# Access Compliance Report

## Public Rights-of-Way

### (Curb Ramps)

Intersection ID: N/A	Main Street: ELGIN_MOOR_RD	Cross Street: DOUGLAS_PALACE_CT	Location: SE
ADA ID: 2CDF9BFCE096	Ramp Type: Perp	Initial Pass/Fail: Fail	Overall Compliance: No
		Severity Score: 12.5

#### Codes/Mitigation Info/Possible Solution

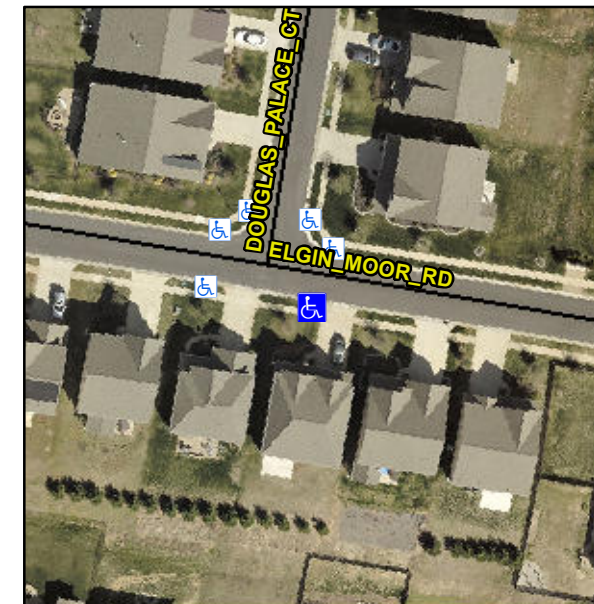
**Not Found, R304.2.2**

Compliance	Description	Data	Compliance	Description	Data
N/A	Ramp Length (in)	48.0	No	Ramp Slope (%)	9.0
Yes	Ramp Width (in)	48.0	Yes	Ramp XSlope (%)	1.2
N/A	Flare Type LT	N/A	N/A	Flare Type RT	N/A
N/A	Flare Slope LT (%)	N/A	N/A	Flare Slope RT (%)	N/A
N/A	Flare Traversable LT?	N/A	N/A	Flare Traversable RT?	N/A
N/A	Landing Length (in)	N/A	N/A	DWS Provided?	N/A
N/A	Landing Width (in)	N/A	N/A	DWS Contrast?	N/A
N/A	Landing Slope (%)	N/A	N/A	DWS Length (in)	N/A
N/A	Landing X Slope (%)	N/A	N/A	DWS Full Width?	N/A
N/A	Landing Curb? (Y/N)	N/A	N/A	DWS Offset (in)	N/A
N/A	Shared Landing?	N/A			
N/A	Gutter Ponding?	N/A	N/A	Gutter Slope (%)	N/A
N/A	Gutter Lip Ht (in)	1.0	N/A	Gutter X Slope (%)	N/A
N/A	Painted X Walk1?	No	N/A	Painted X Walk2?	N/A
	X Walk 1 Direction	To NE		X Walk 2 Direction	N/A
N/A	X Walk 1 Width (in)	N/A	N/A	X Walk 2 Width (in)	N/A
	X Walk 1 Slope (%)	2.2		X Walk 2 Slope (%)	N/A
	X Walk 1 X Slope (%)	1.7		X Walk 2 X Slope (%)	N/A

**Remove & Replace Entire Ramp.**
